AMENDMENTS TO THE DRAWINGS

REMARKS

U.S. Patent App. Entitled: "Programming of Multi-Level Memory Cells on a Continuous Word Line";
Inventor: Sau Ching Wong; Attorney Docket No.: MLM006US1P

25/29

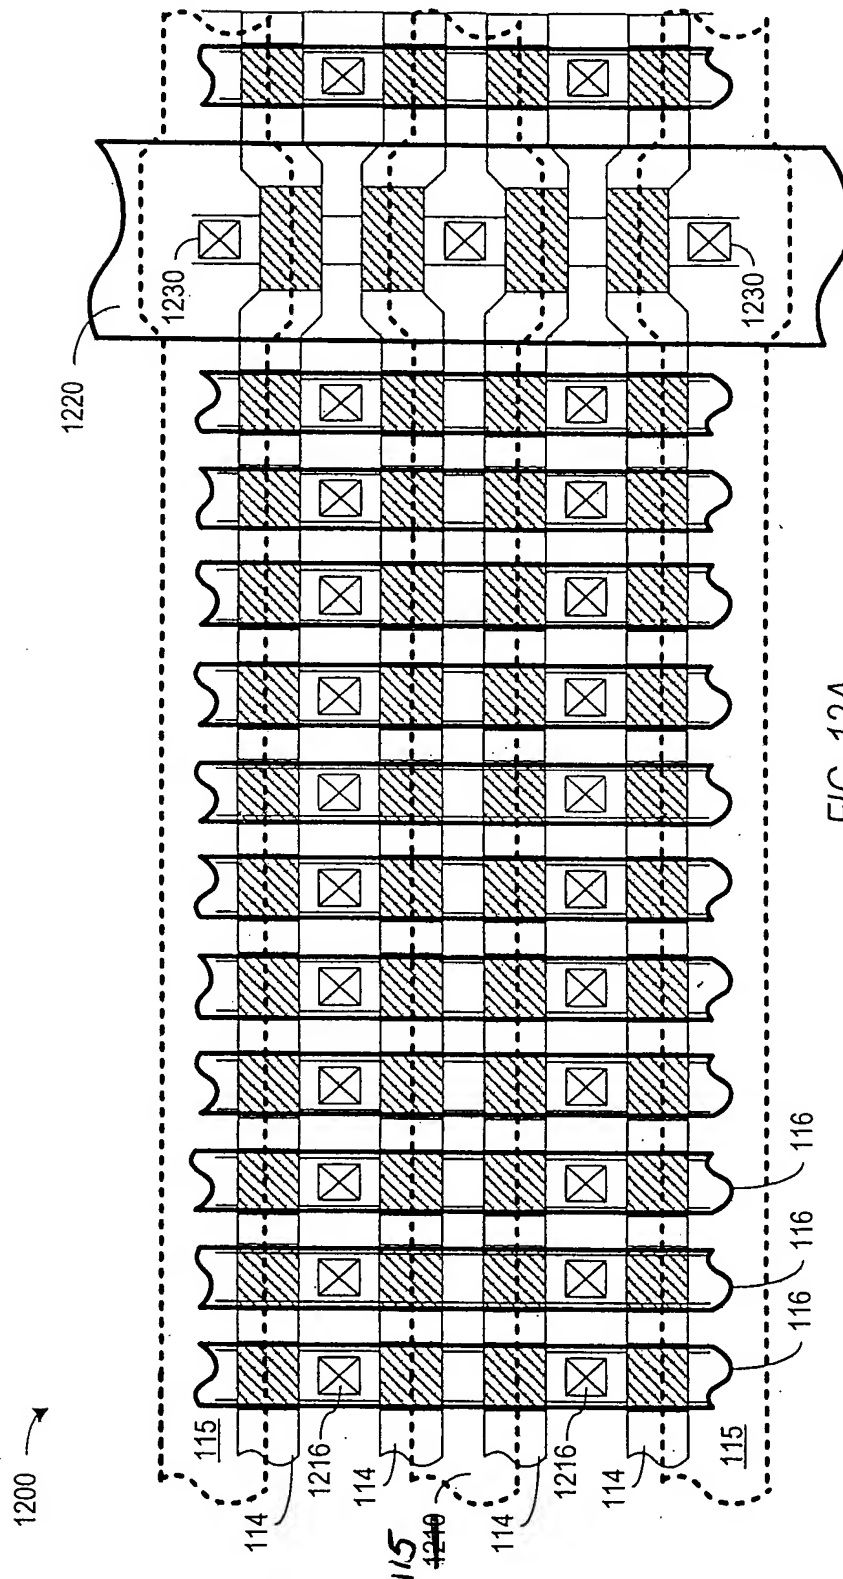
The attached sheets of drawings include changes to FIGs. 3G, 12A and 13. These sheets, which include FIG. 4, replace the original sheets including FIGs. 3G, 12A and 13. In FIG. 3G, reference number 318 replaces reference number 312. In FIG. 12A, reference number 115 replaces reference number 1210. In FIG. 13, reference numeral 1300 is added.

In regard to the first basis of objection, Applicant hereby amends FIG. 12A to replace reference numeral 1210 with reference numeral 150.

FIG. 13

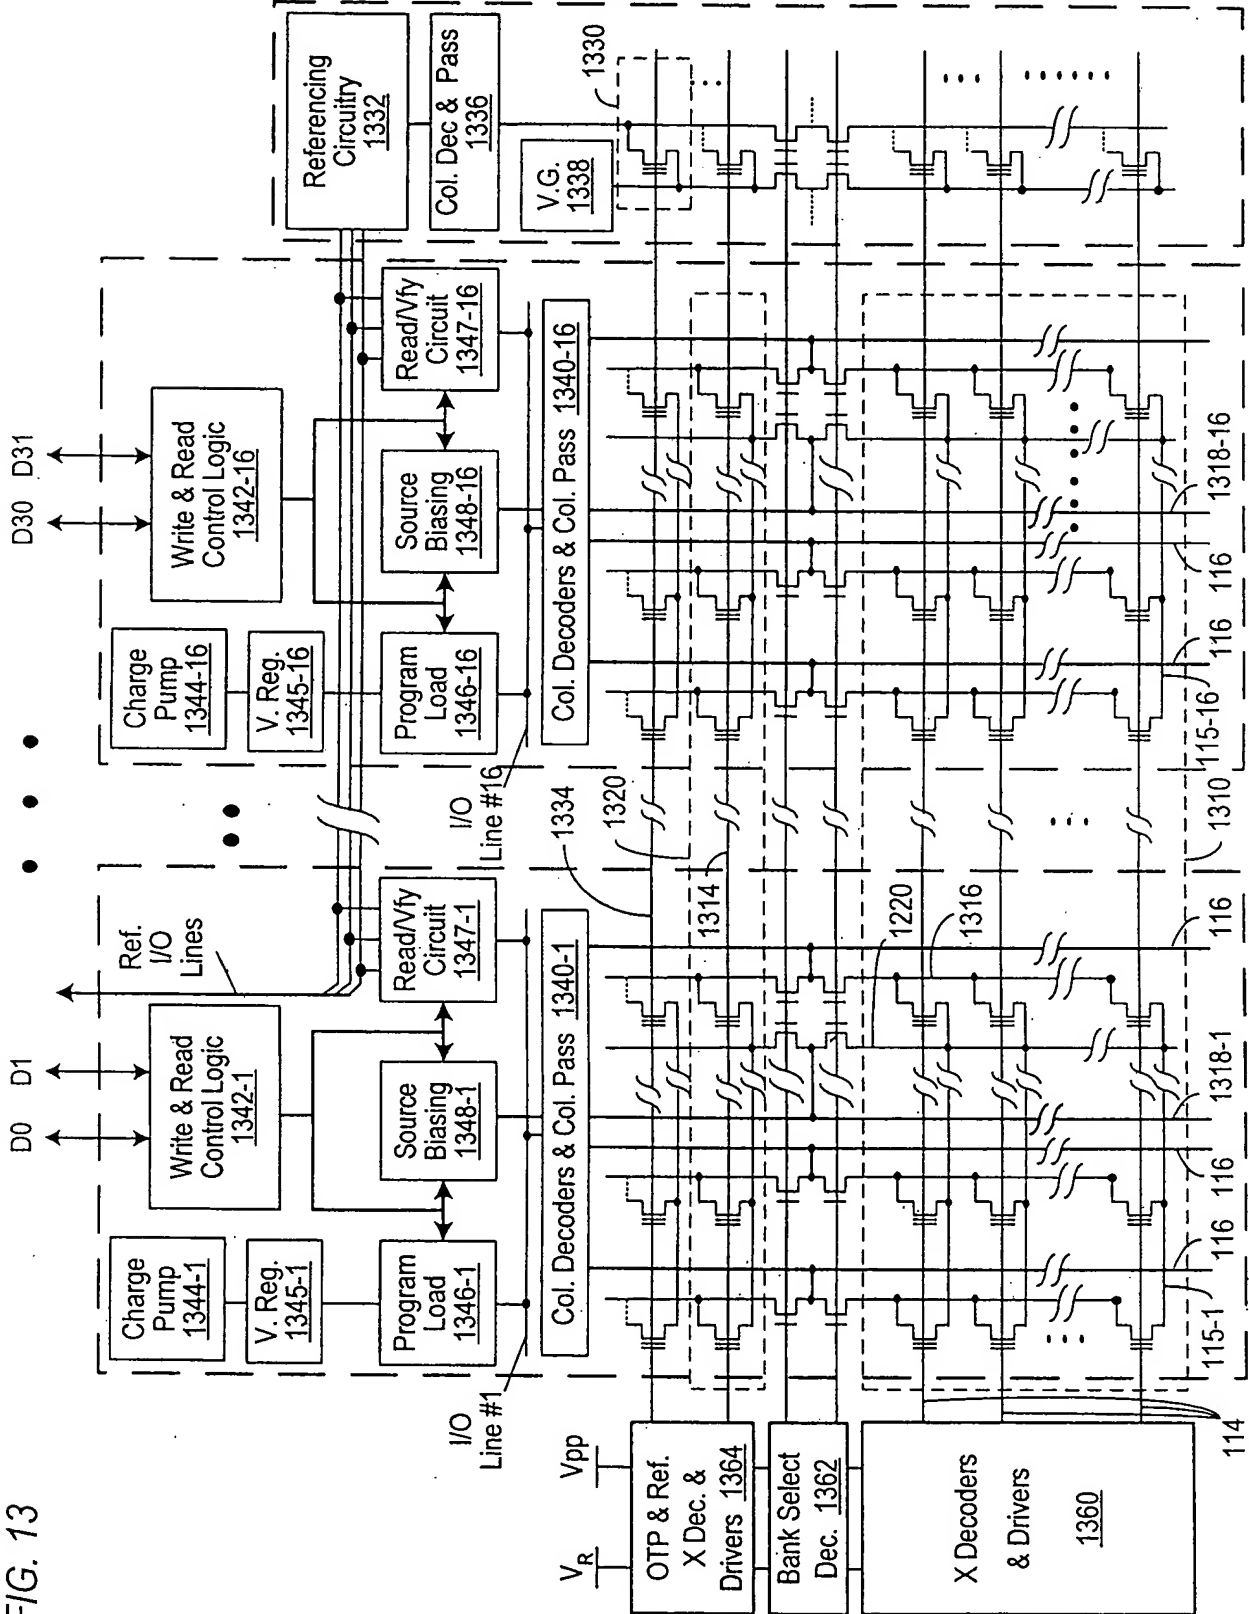
In regard to the second basis of objection, Applicant hereby amends: FIG. 3G to replace reference numeral 312 with reference numeral 318; FIG. 13 to show reference character 1300; and paragraph [0100] to replace "1040" with "1060."
